RE: ENGINEER'S CERTIFICATION FOR WEST LANG AVE - TRACT 1A (D-17/D3V)
RECEIVED NOVEMBER 7, 1995 FOR DRAINAGE REQUIREMENTS
ENGINEER'S STAMP DATED 11/6/95

Lang Avenue Storm Drain Analysis

PROJECT NAME Journal Center - Tract 1A SHEET OF

TITLE: JOURNAL CENTER BUSINESS PARK - TRACTIA LANG AVENUE PAVING PLAN AND PROFILE					
APPROVALS	ENGINEER	DATE	APPROVALS	ENGINEER	DATE
DRG. CHAIRMAN			WATER		
TRANSPORTATION			WASTE WATER		
HYDROLOGY					
DRAWING NO.		MAP NO. D-17		SHEET 3	OF 7

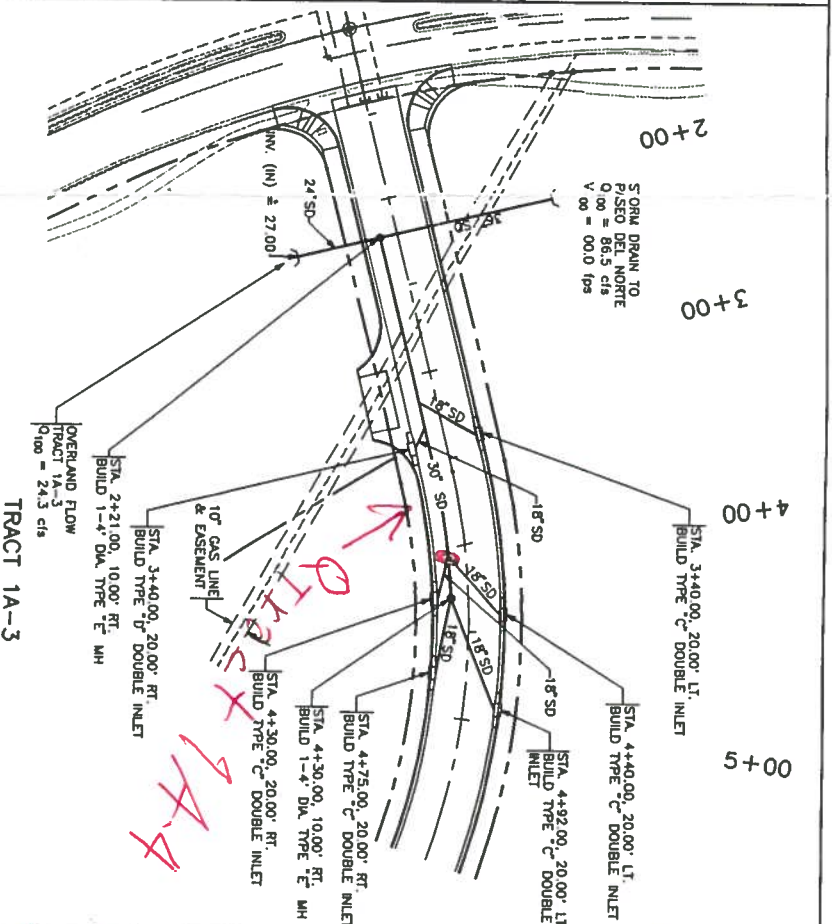
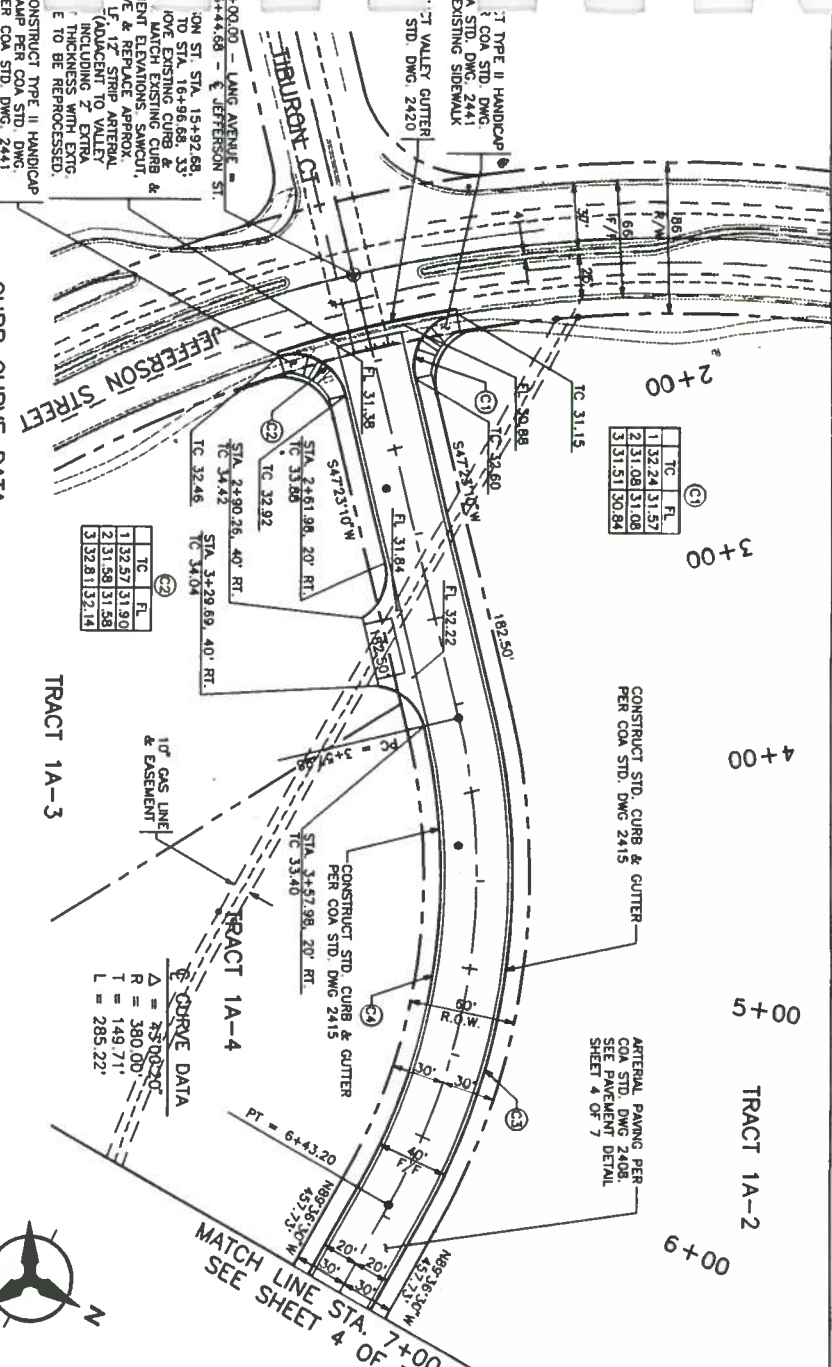
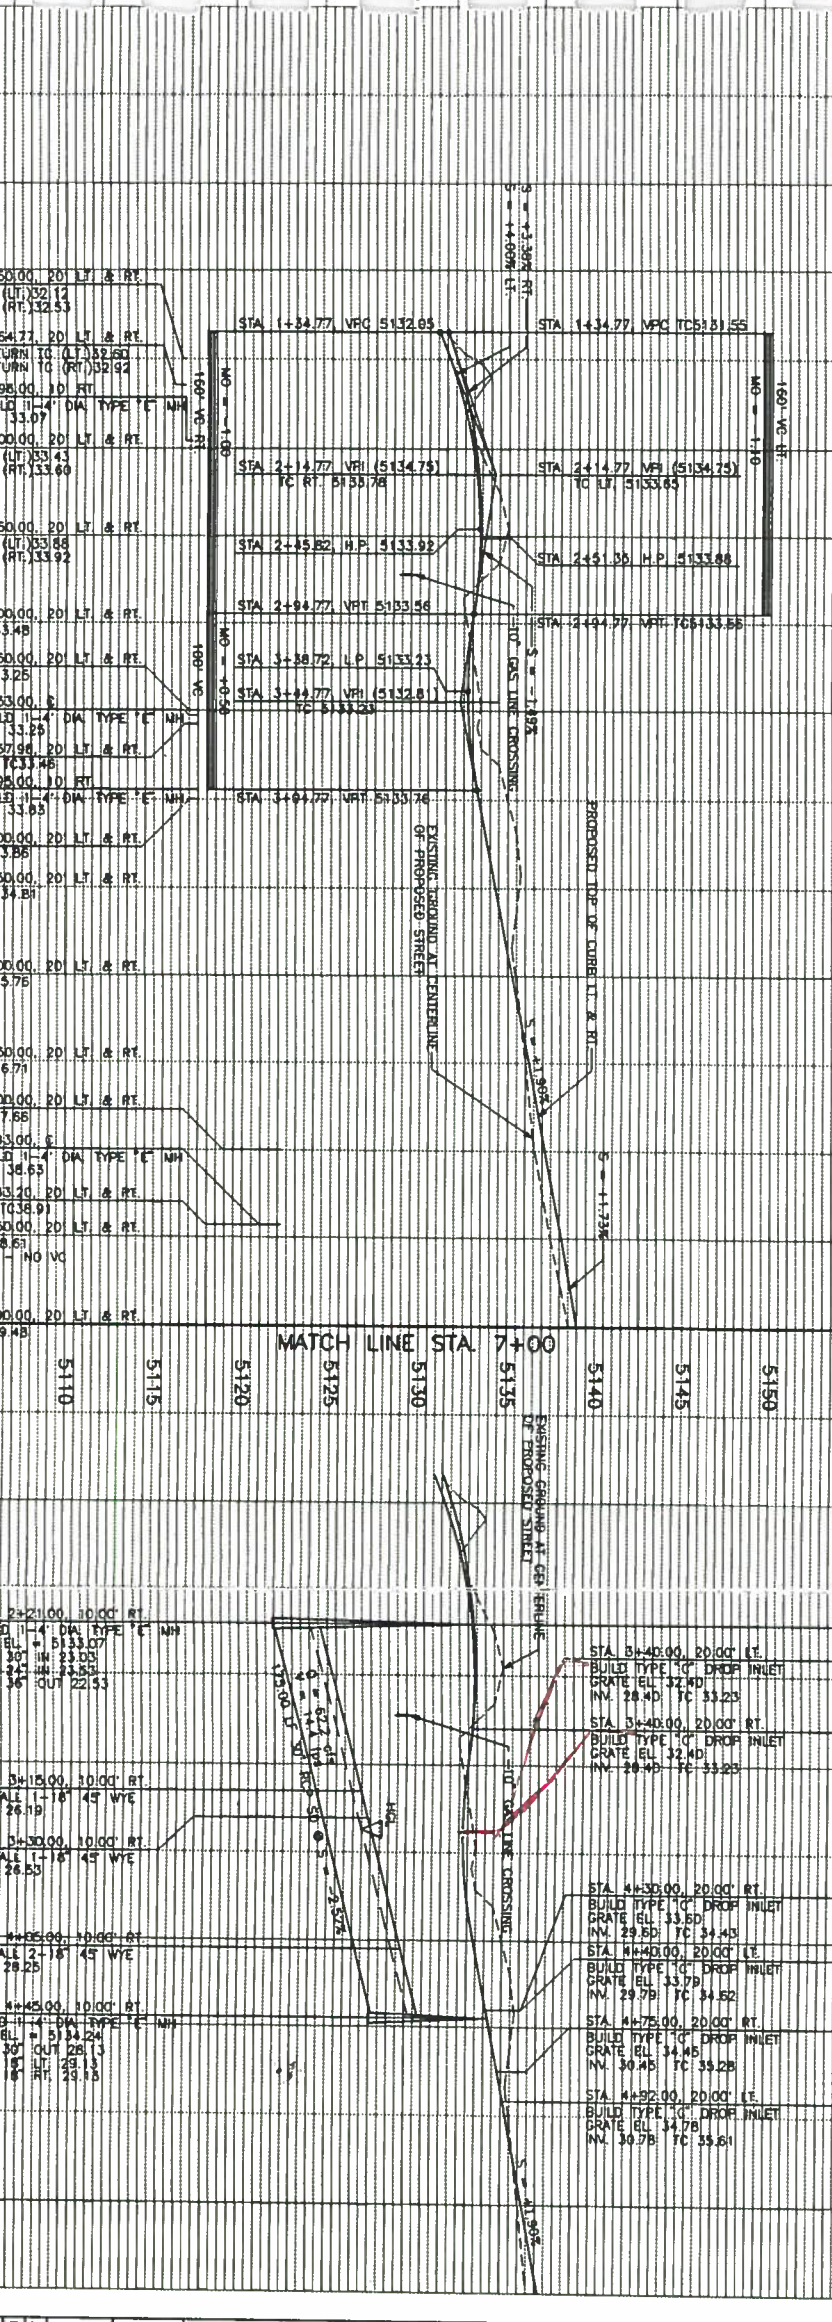
How does Tract 1A-4 drain to Lang?

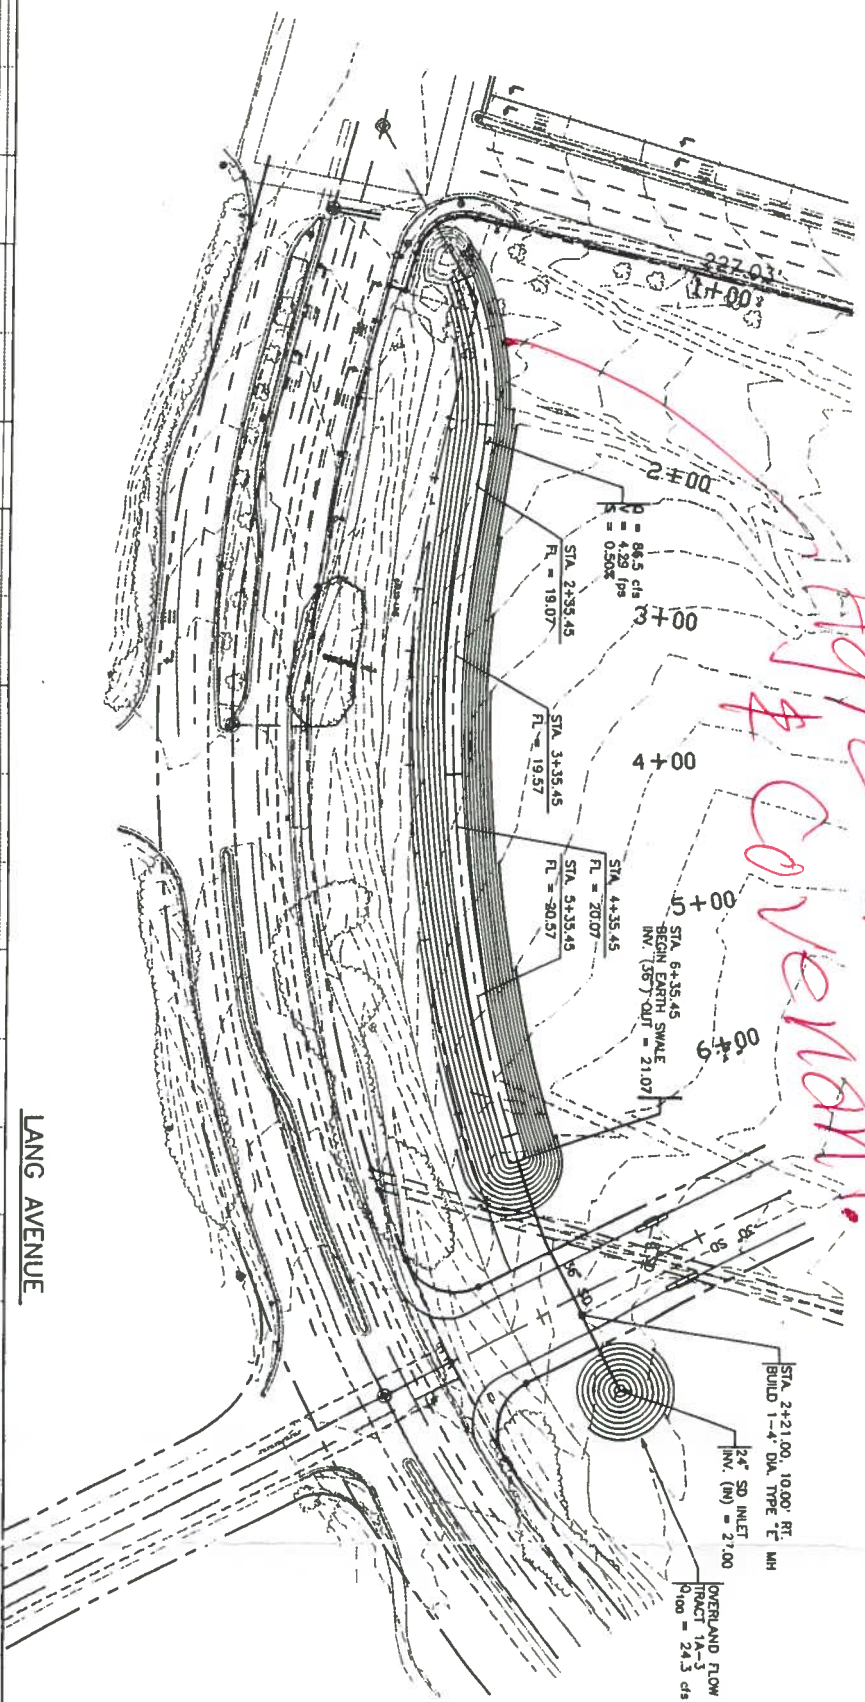
*Agreement
Covenant*

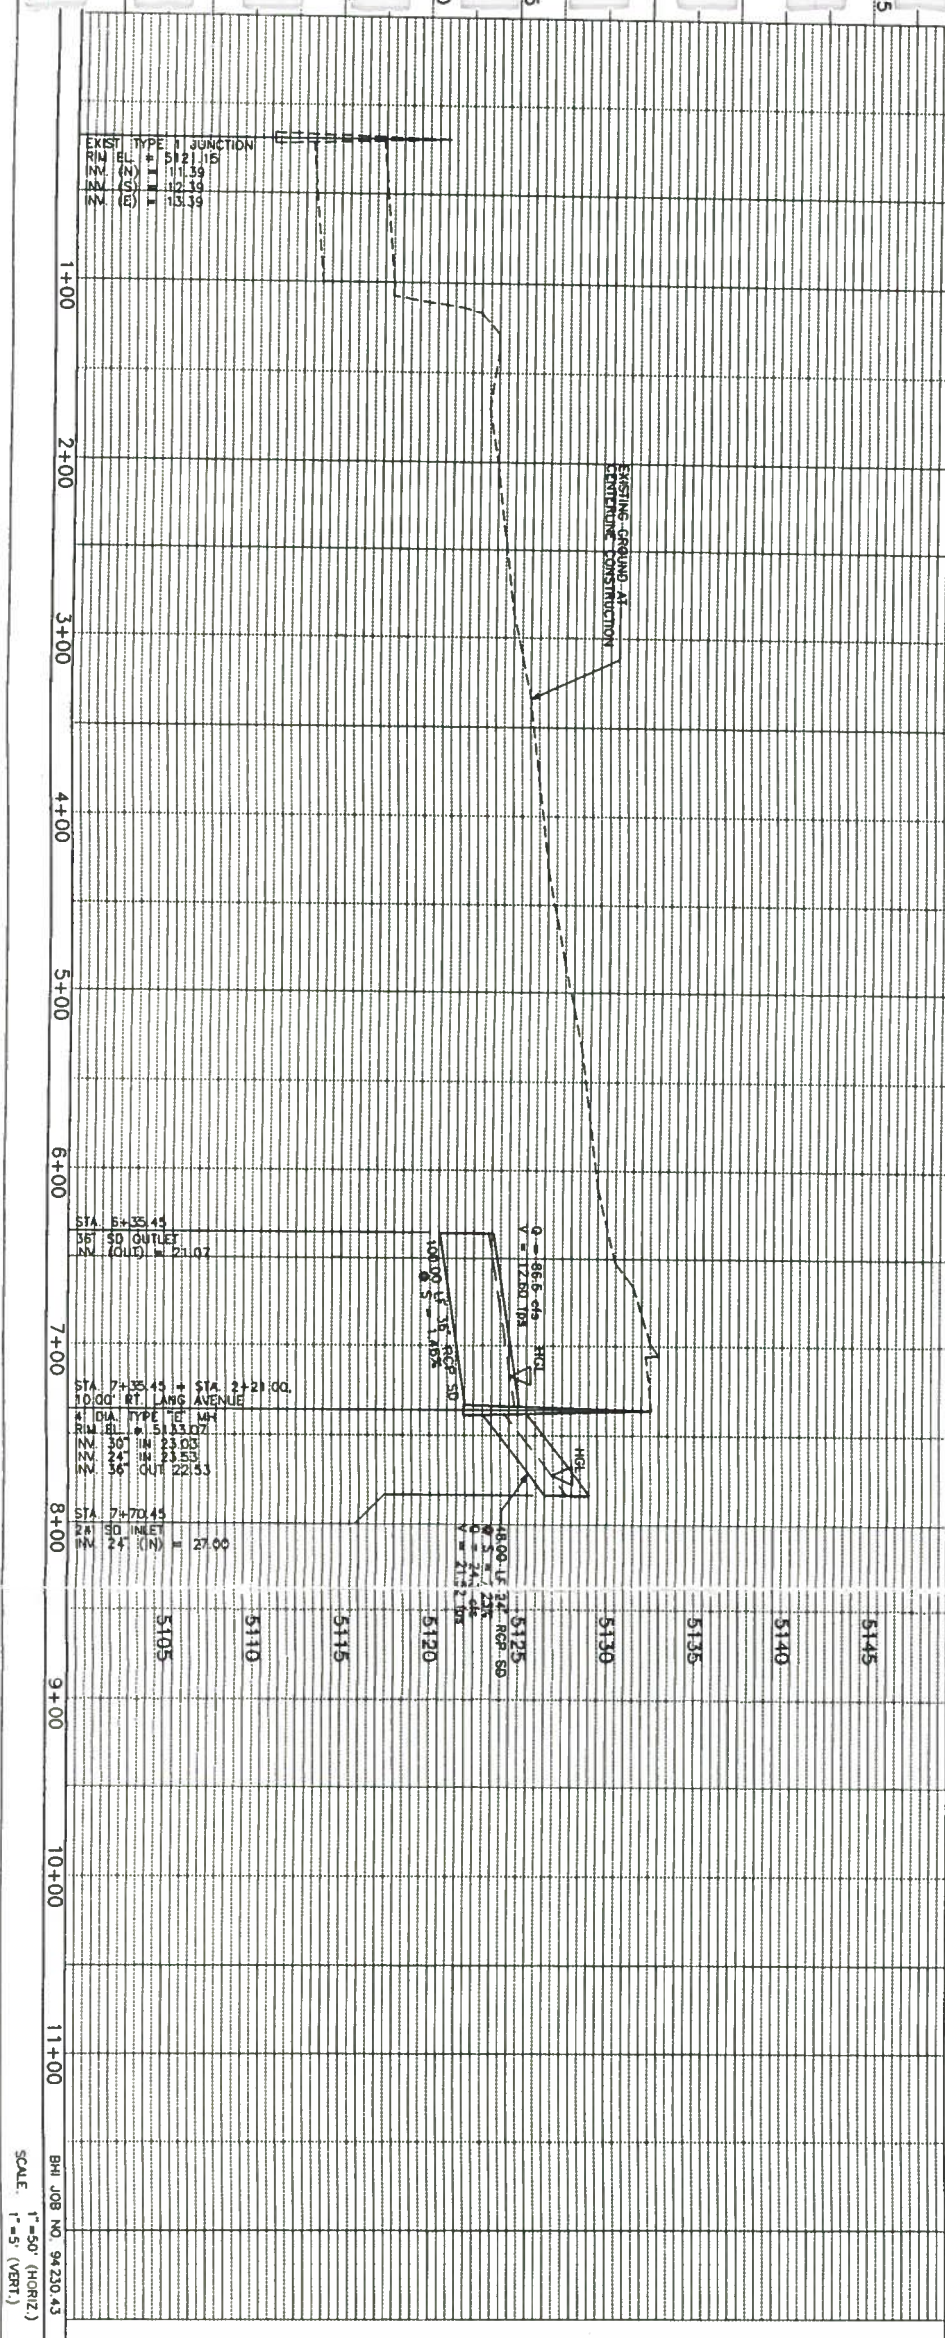
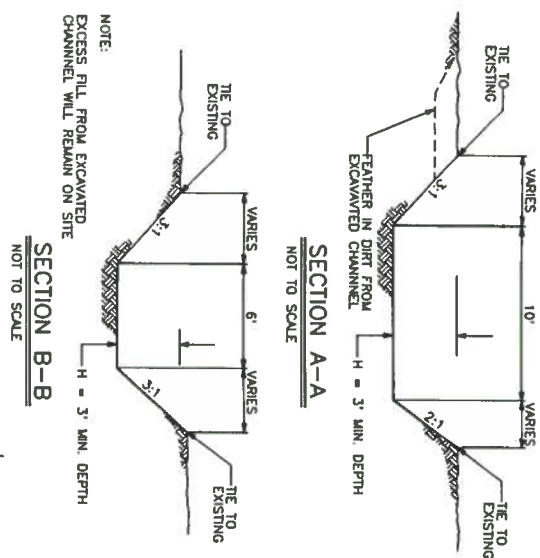
Lined?

Provide Design for sediment Basin. State Criteria Used.
